SUBJECT: ISSUANCE OF AMENDMENT FOR JAMES A. FITZPATRICK NUCLEAR POWER PLANT
(TAC NO. M95523)

AMENDMENT NO. 237 TO FACILITY OPERATING LICENSE NO. DPR-59-FITZPATRICK

SAFETY EVALUATION BY THE OFFICE OF NUCLEAR REACTOR REGULATION
RELATED TO AMENDMENT NO. 237 TO FACILITY OPERATING LICENSE NO. DPR-59
POWER AUTHORITY OF THE STATE OF NEW YORK
JAMES A. FITZPATRICK NUCLEAR POWER PLANT
DOCKET NO. 50-333

Figure 1 Demonstrates effect on peak pressure from assuming 1 out of service SRV. The difference in pressure is approximately 70 psi.

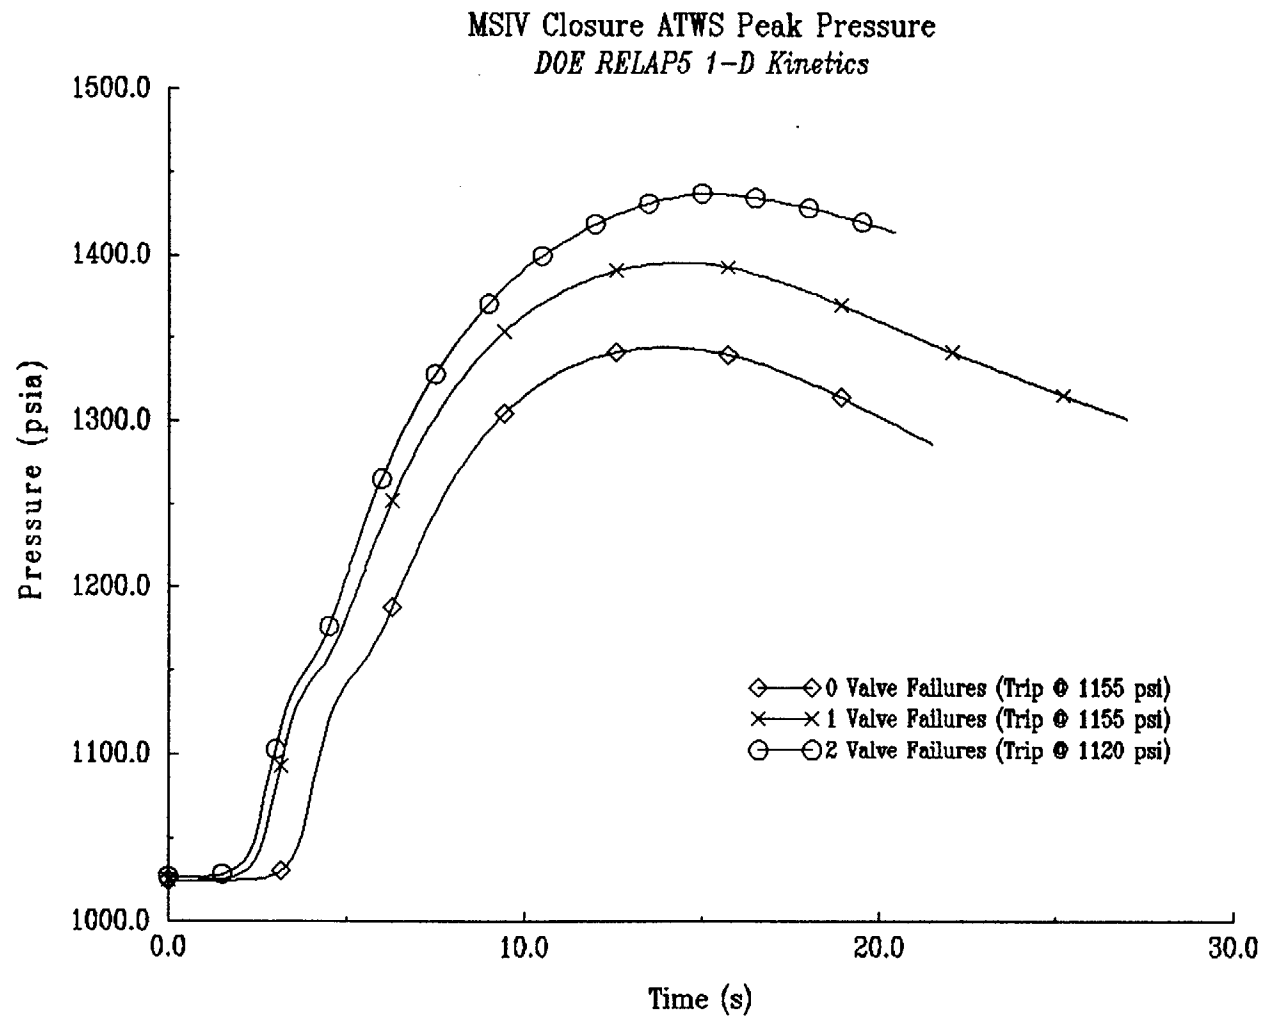
calculating the pressure rise assuming no SRV failures. This effect was confirmed by the staff using the RELAP5¹ code and was calculated to be 70 psi (see Figure 1).
